From: Traversi, Richard@CDCR [mailto:Richard.Traversi@cdcr.ca.gov]
Sent: Wednesday, November 07, 2012 11:57 AM
To: CBSC@DGS
Subject: FW: CDCR comments 45-Day Express Terms DSA CBC

CDCR PROPOSED LANGUAGE IN RESPONSE TO
45-DAY EXPRESS TERMS
FOR
PROPOSED BUILDING STANDARDS
OF THE
DIVISION OF THE STATE ARCHITECT (DSA-AC)
REGARDING THE CALIFORNIA BUILDING CODE
CALIFORNIA CODE OF REGULATIONS, TITLE 24, PART 2
2013 CALIFORNIA BUILDING CODE

Figure 608.2.1

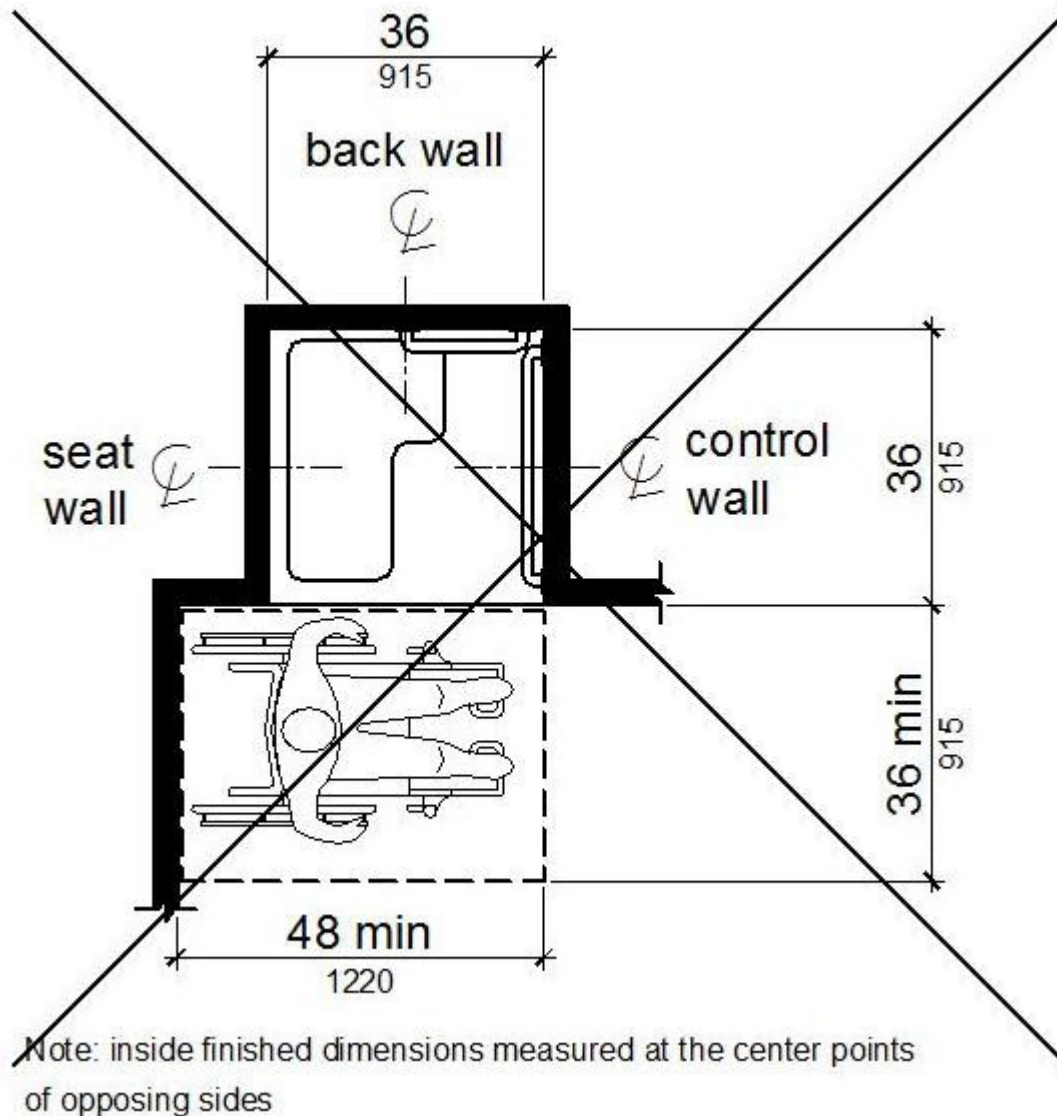
Justification: Exception 5: detention and correctional facilities are constructed with load-bearing concrete or CMU walls and it is technically infeasible to construct a compliant roll-in type shower compartment in many existing facilities due to location of existing load-bearing walls and lack of available alternate space. Exception 6: providing different types of accessible shower compartments permits inmates with a range of disabilities to have greater access; the roll-in type shower compartment may not provide as much access as a transfer type shower compartment for some disabled individuals. The 2010 ADAS deems the transfer type shower compartment to provide access for the disabled.

~~11B-608.2.1 Reserved.~~ Transfer Type Shower Compartments as permitted by 11B-213.2 Exceptions 5 & 6. Transfer type shower compartments shall be 36 inches (915 mm) by 36 inches (915 mm) clear inside dimensions measured at the center points of opposing sides and shall have a 36 inch (915 mm) wide minimum entry on the face of the shower compartment. Clearance of 36 inches (915 mm) wide minimum by 48 inches (1220 mm) long minimum measured from the control wall shall be provided.
